Appl. No. 10/689,390 Amdt. dated July 27, 2006 Reply to Original action of 02 May 2006

Amendments to the Drawings:

REMARKS/ARGUMENTS

Annutated Sheet 3/8 9

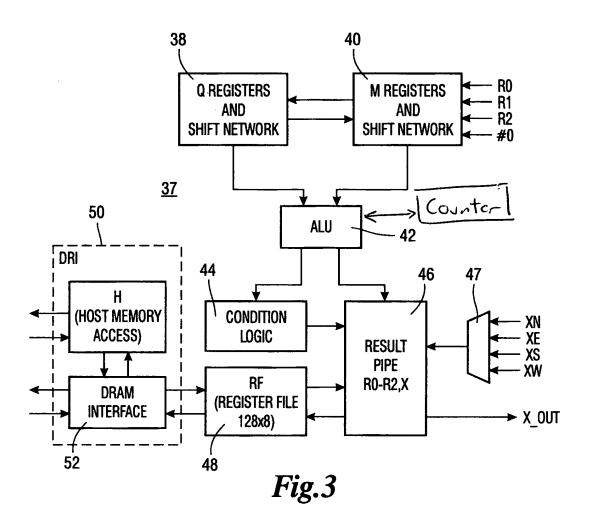
The examiner has also suggested "adding a figure for a processing element containing a counter" with respect to the subject matter of claims 2, 9, 16, 23, and 30. Instead of adding an additional figure, FIG. 3 has been amended to add a counter.

Amendments to the drawings include the addition of the legend "PRIOR ART" to FIG. 1, the addition of a counter to FIG. 3, the addition of a new sheet of drawings carrying FIGs. 17A and 17B, and the renumbering of all the sheets to reflect that there are now nine sheets of drawings and not eight.
